Project	IEEE 802.16 Broadband Wireless Access Working Group < <a href="http://ieee802.org/16">http://ieee802.org/16</a> >		
Title	A method to implement Inter-system communication over air		
Date Submitted	2007-03-09		
Source(s)	Shulan Feng Hisilicon Tech. Co., LTD Bld.17, No.8, Dongbeiwang West Road, Hai-Dian District, Beijing, P. R. China	Voice: +86-10-82829151 Fax: +86-10-82829075 e-mail to : <a href="mailto:fengsl@hisilicon.com">fengsl@hisilicon.com</a> , <a href="mailto:fengsl@huawei.com">fengsl@huawei.com</a>	
Re:	IEEE 802.16 Working Group Letter Ballot #24a, on P802.16h/D2		
Abstract	There are many messages in current P802.16h/D2 which require SS send message to its neighbor BS. But BS may not correctly receive an uplink burst without performing ranging procedure. So we propose BS schedule Inter-system communication time slot for SS. Before send any message to neighbor BS, SS should perform ranging procedure using scheduled Inter-system communication time slot.

## A Method to Implement the Inter-system Communication over Air

Figure 2 procedure of Inter-system communication

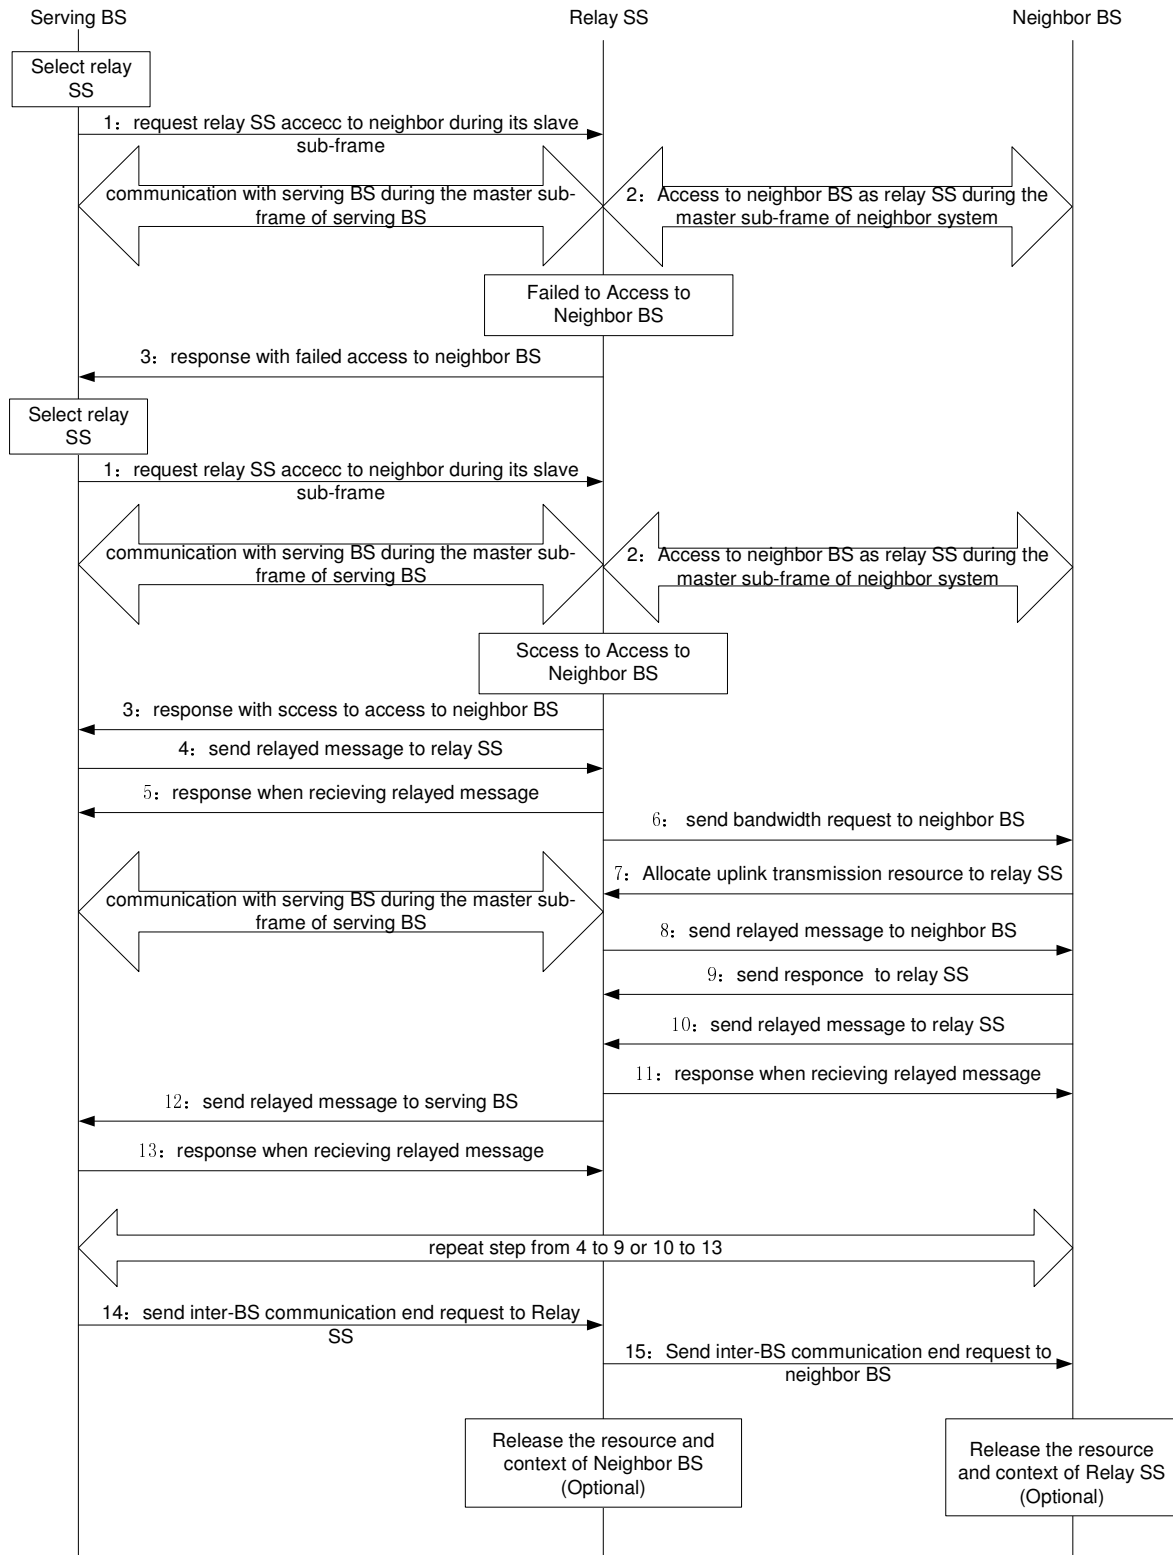
*[ Add a new clause 15.x ]*

## 15.x Inter-system communication over air

When some messages need to send to its neighbor BS over air, serving BS may select one or more SSs as relay between two BSs. The relay SSs are always the SSs which in the overlapped area of two BSs, that is, the interference victim SSs of caused by interference neighbor BS. These SSs communicate with serving BS during the serving BS's master sub-frame and are idle during the serving BS's slave sub-frame.

After determine the relay SS, serving BS may request relay SS to access to neighbor BS via Access-NBS-REQ message. Upon receiving the access neighbor BS request, relay SS will try to access neighbor BS during the master sub-frame of neighbor BS. It will try to establish synchronization with neighbor BS, obtain transmission parameter, perform ranging, negotiate basic capabilities, be authorized and exchange key, perform registration. These procedures are performed during the neighbor BS's master sub-frame and just like a normal SS network entry procedure described in section 6.3.9. Neighbor BS will allocate Basic CID, primary management CID and secondary management CID to relay SS. But in the RNG-REQ message, relay SS should tell its neighbor BS it communicates with neighbor via parameter "SS attribute" just for Inter-system communication and the BSID of its serving BS via parameter "serving BSID".
